# Service Bulletin

Bulletin No.: PIP5065

**Subject:** Ticking Noise in 3rd and 4th Gear Above 30 MPH.

**Models:** 2010-2012 Chevrolet Colorado  
2010-2013 Chevrolet Express, Silverado  
2010-2012 GMC Canyon  
2010-2013 GMC Savana, Sierra

2914493

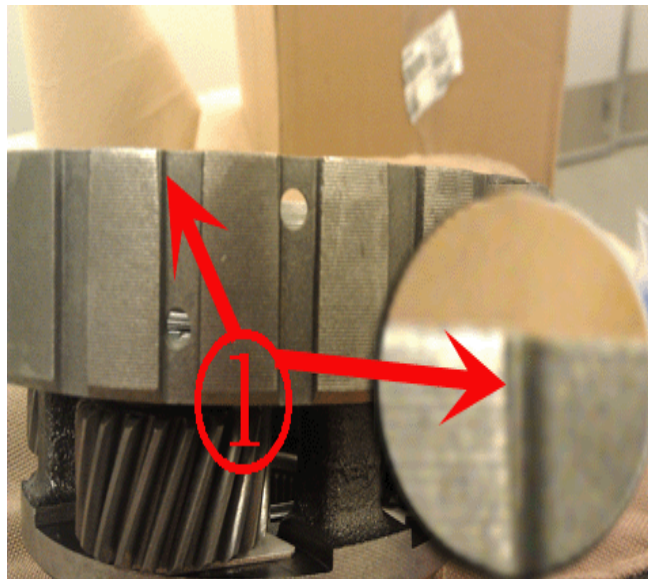
### Call out 1

Shows a taper in the machined surface of the reaction carrier lug.

This mis-machined hub is causing the low reverse clutch plates to stick and release creating the ticking noise

Replace the Reaction Carrier and low reverse clutch plates.
